Access Compliance Report

Public Rights-of-Way

Intersection ID: N/A	Main Street: FINCHER_FARM_RD	Cross Street: N/A	Location: SW
ADA ID: CDA973E34F97	Ramp Type: PerpDiag	Initial Pass/Fail: Fail	Overall Compliance: No
		Severity Score: 25

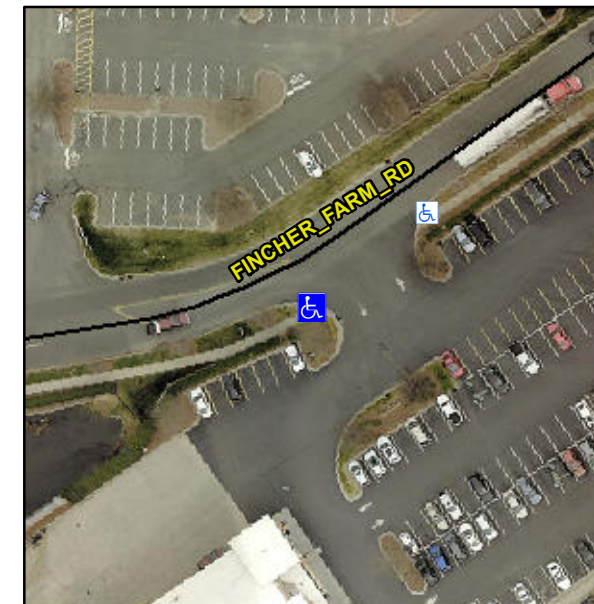
Not Found, R304.5.3

Compliance	Description	Data	Compliance	Description	Data
N/A	Ramp Length (in)	65.0	Yes	Ramp Slope (%)	5.1
Yes	Ramp Width (in)	48.0	No	Ramp XSlope (%)	7.5
N/A	Flare Type LT	N/A	N/A	Flare Type RT	N/A
N/A	Flare Slope LT (%)	N/A	N/A	Flare Slope RT (%)	N/A
N/A	Flare Traversable LT?	N/A	N/A	Flare Traversable RT?	N/A
N/A	Landing Length (in)	N/A	N/A	DWS Provided?	N/A
N/A	Landing Width (in)	N/A	N/A	DWS Contrast?	N/A
N/A	Landing Slope (%)	N/A	N/A	DWS Length (in)	N/A
N/A	Landing X Slope (%)	N/A	N/A	DWS Full Width?	N/A
N/A	Landing Curb? (Y/N)	N/A	N/A	DWS Offset (in)	N/A
N/A	Shared Landing?	N/A			
N/A	Gutter Ponding?	N/A	N/A	Gutter Slope (%)	N/A
N/A	Gutter Lip Ht (in)	N/A	N/A	Gutter X Slope (%)	N/A
N/A	Painted X Walk1?	No	N/A	Painted X Walk2?	No
	X Walk 1 Direction	To NE		X Walk 2 Direction	To NW
N/A	X Walk 1 Width (in)	N/A	N/A	X Walk 2 Width (in)	N/A
	X Walk 1 Slope (%)	0.8		X Walk 2 Slope (%)	7.6
	X Walk 1 X Slope (%)	9.4		X Walk 2 X Slope (%)	3.4

Remove & Replace Curb Ramp With Two New Directional Ramps or Equivalent.
